Addendum 47: Regulation No. 48

Revision 6 – Amendment 5

05 series of amendments - Date of entry into force: 30 January 2011

**Uniform provisions concerning the approval of vehicles with regard to the
installation of lighting and light-signalling devices**

Model A

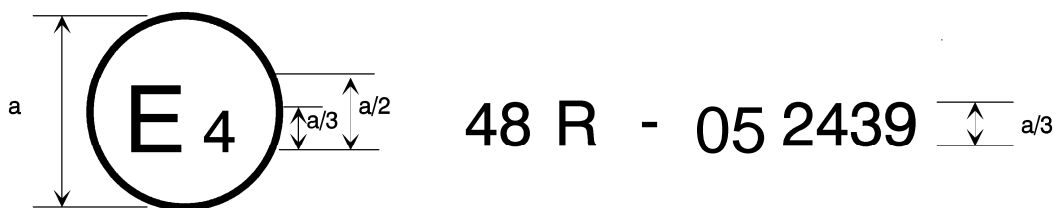
Annex 2, amend to read:

The above approval mark affixed to a vehicle shows that the vehicle type concerned has, with regard to the installation of lighting and light-signalling devices, been approved in the Netherlands (E4) pursuant to Regulation No. 48 as amended by the 05 series of amendments. The approval number indicates that the approval was granted in accordance with the requirements of Regulation No. 48 as amended by the 05 series of amendments.

Model B

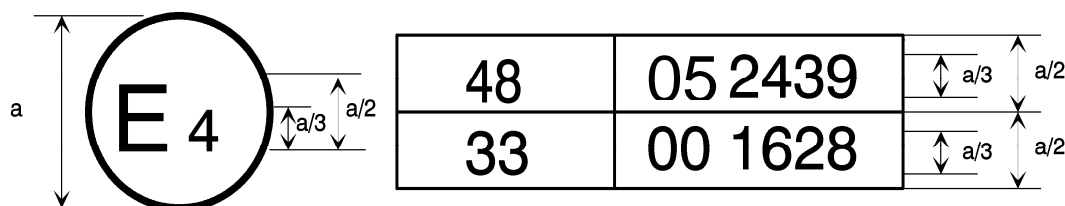
The above approval mark affixed to a vehicle shows that the vehicle type concerned has been approved in the Netherlands (E4) pursuant to Regulation No. 48 as amended by the 05 series of amendments and Regulation No. 33¹. The approval number indicates that, at the dates when the respective approvals were given, Regulation No. 48 was amended by the 05 series of amendments and Regulation No. 33 was still in its original form.
